A417 Missing Link  
TR010056

8.35 Comments on Responses  
received by Deadline 8

**Comments on Responses received by Deadline 8**

**Figure 4-1 Screen shot current land acquisition overlain with the current access track and proposed realigned access track.**

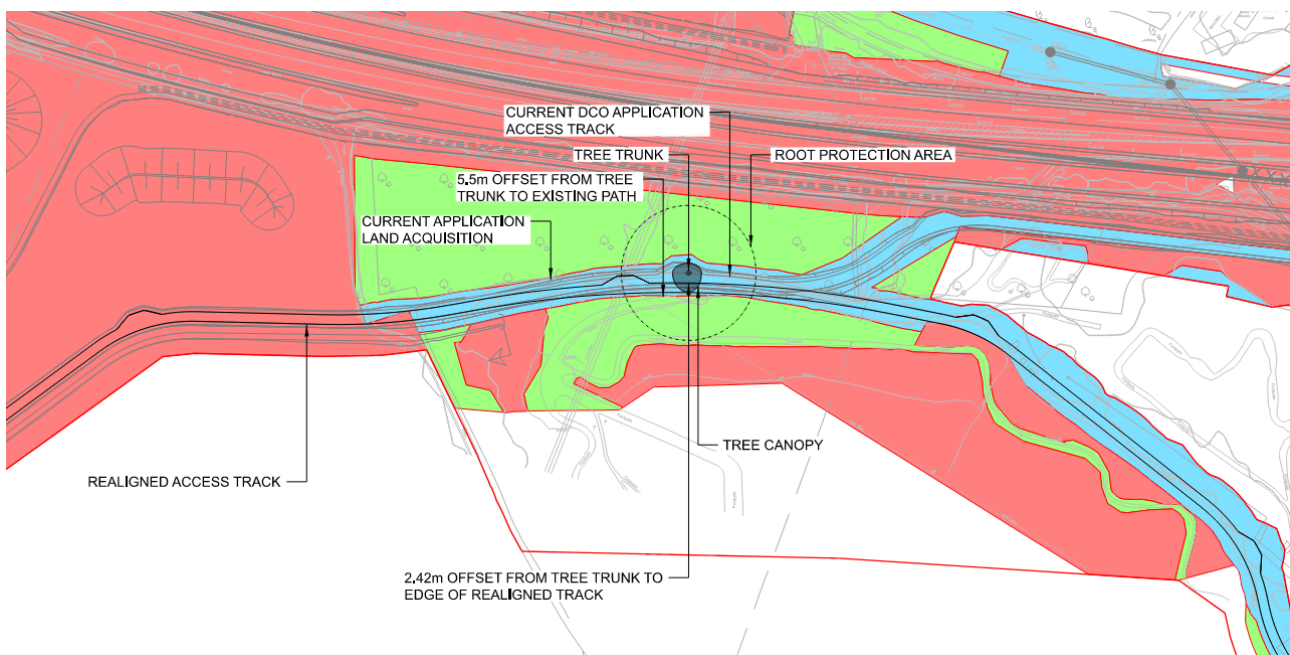
- 4.4.1 Since the Deadline 8 submission, National Highways has continued to review the scheme design in the location of the newly identified ancient tree. As noted under section 6.2 of Comments on Responses received by Deadline 7 and 7a and Changes to the Application (Document Reference 8.33, REP8-029), all ancient trees are veteran trees.

- 4.4.2 National Highways is now confident the track can be realigned, and the tree can be retained and accommodated within the scheme design and current land take. It is accepted that encroachment into the rooting environment of the retained tree with specific mitigation measures is considered preferable to the loss of this individual tree.

- 4.4.3 Measures identified to mitigate the impact on the tree include:
- A no dig solution to minimise the compaction of the underlying root system. This system will be laid on top of the existing ground surface as a subbase with a permeable wearing course on top. This would protect major roots (over

25mm) but also the important fibrous root system often found close to the surface.

- Use of a cellular confinement system to provide protection for the roots. This would distribute the weight of the traffic which in turn prevents subsoil compaction around the roots.
- Raising the track level.

4.4.5 is based on the Land Plans (Document Reference 2.2 (Rev 2), REP4-006) and shows the current land acquisition overlain with the current access track as shown on General Arrangement Plans (Document Reference 2.6a (Rev 2), REP4-009). It also shows the proposed realigned access track, which has a 2.42m offset from the trunk of the veteran tree to the realigned track.
